DOCUMENT CHANGE REQUEST

DCR number 334	Changes required for: General	Originator: S Jeffery
Date: 2007/04/17	Date sent: 2007/04/17	Organisation: ESA/ESTEC
Status: IMPLEMENTED

Title:	Matched Dual Transistors NPN, based on types 2N2919/2N2920 and 2N2920A		
Number:	5207/002	Issue:	1

ESCC Detail Specification No. 5207/002

1.5 MAXIMUM RATINGS

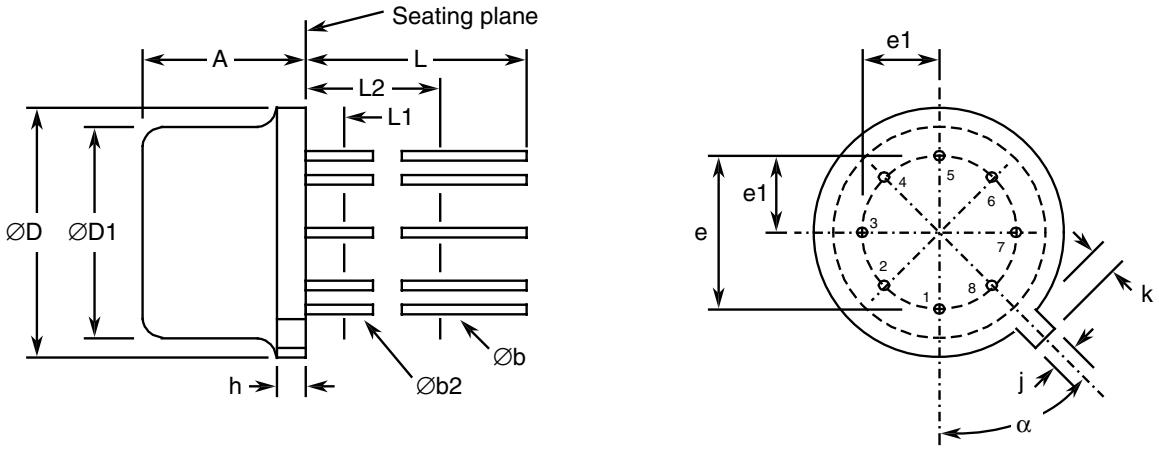
4. Deletion of obsolete Variant 01 from the available range (not supported by either STMicroelectronics or Semelab).
5. Figure 1(a) Parameter Derating Information moved to be a note in the Maximum Ratings table.

6. Maximum Ratings Table: Power Dissipation Characteristics amended/corrected (now "Power Dissipation (One Section)" and "Power Dissipation (Both Sections)").

1.6.1 Metal Can Package (TO-77) - 6 lead

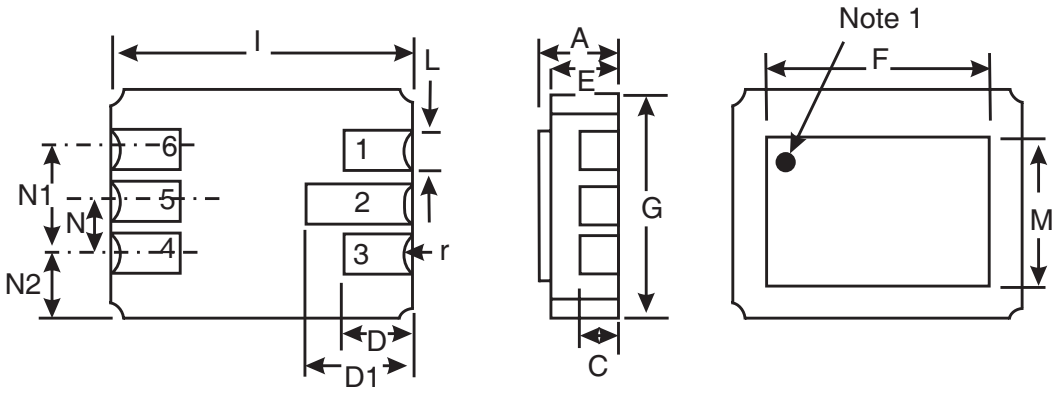
7. Para. 4.3.2 Weight requirements moved to Component Type Variants table.
8. Figure 2 re-named "Physical Dimensions and Terminal Identification"; Figure 2(a) amended to reflect the TO-77 package currently supplied; Figure 2(b) amended to reflect the CCP package currently supplied.
